NOTICE OF VIOLATION

On January 29, 2025, Energy Safety conducted an inspection of PG&E's WMP initiatives in the vicinity of the city of Applegate, California. The inspection report is enclosed herewith. Energy Safety found the following violation(s):

INSPECTION REPORT

Electrical Corporation:	Pacific Gas and Electric Company				
Report Number:	CAD_PGE_BKA_20250129_1136				
Inspector:	Babak Kaviani				
WMP Year Inspected:	2024				
Quarterly Data Report (QDR) Referenced:	Quarter 2 (Q2)				
Inspection Selection:	Energy Safety viewed the contents of the Q2 QDR and performed an analysis that resulted in the selection of				
	the WMP initiatives and locations referenced in this report.				
Relevant WMP Initiative(s):	8.1.2.10.5 – Non-Exempt Expulsion Fuses				
Date of inspection:	January 29, 2025				
City and/or County of Inspection:	Applegate, Placer County				
Inspection Purpose:	Assess the accuracy of PG&E's QDR data, completeness of its work, compliance with WMP requirements, and				
	compliance with its protocols.

Item1GImg1: Overall pole

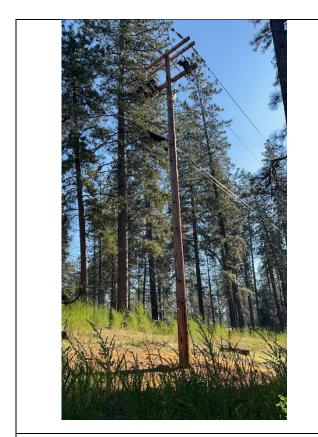
On pole ID 067349, Grid Hardening ID 31659986 at 230-280 Yonehiro Drive, Applegate, CA, 95703, USA, 39.014956, -120.982036, the inspector observed that the CalFire-exempt fuses were not attached to the cutouts. The inspector's observation is documented in Violation 1 photographs, which are attachments to this report. Photo numbers Item1GImg1, Item1GImg2, Item1IA1Img1, Item1IA1Img2 depict incomplete installation of CalFire-exempt fuses. PG&E reported that work on WMP initiative 8.1.2.10.5 – Non-Exempt Expulsion Fuses were completed at this location.

1. The CalFire-exempt fuses were not attached to the cutouts.
